SUBMIT IN TRIPLICATE - Other instructions on reverse side				7. If Unit or CA/Agreement, Name and/or N		
1. Type of Well  X Oil Well Gas Well Other  2. Name of Operator  OXY USA Inc. 16696				8. Well Name and No. Triple S 33 #1 Federal 9. API Well No.		
3a Address P.O. Box 50250 Midland, TX 7971 4. Location of Well (Footage, Sec., T., R., M., or Survey I 1980 FNL 2310 FEL SWNE(G) Sec 33	3b. Phone No (include area code) 432-685-5717		30-015-25769  10. Field and Pool, or Exploratory Area Sand Dunes Delaware, West  11. County or Parish, State Eddy NM

# Triple S 33 Federal #1 API No. 30-015-25769

### Triple S 33 Federal #1 30-015-25769 Oxy USA Inc. July 14, 2011 Conditions of Approval

OXY USA Inc. - Current Triple S 33 Federal #1 API No. 30-015-25769

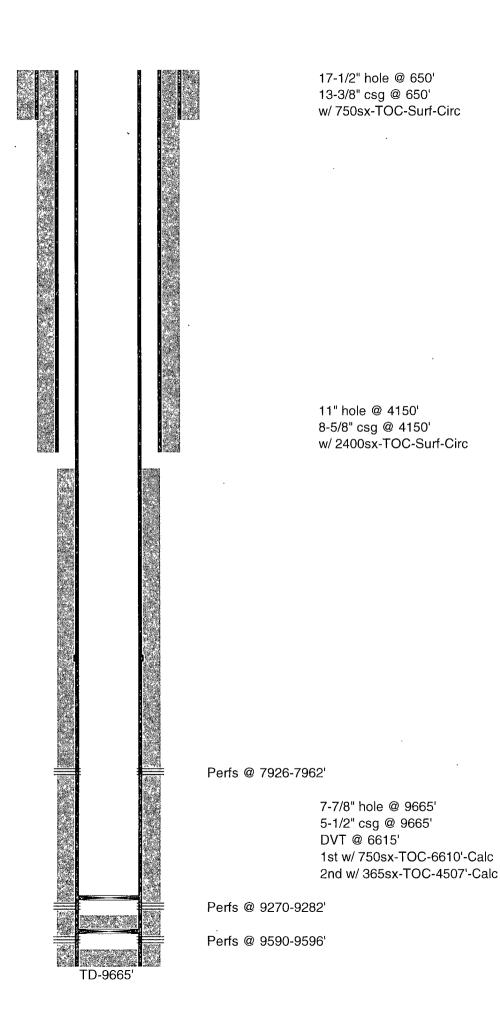
- 1. Class H cement must be used when spotting cement on the CIBP @ 9240'.
- 2. Spot a minimum of 50' of class H cement, 35' if using a dump bailer, on the CIBP @ 8030'.
- 3. Surface disturbance beyond the originally approved pad must have prior approval.
- 4. Closed loop system required.
- 5. Subsequent sundry with completion record and wellbore schematic required.
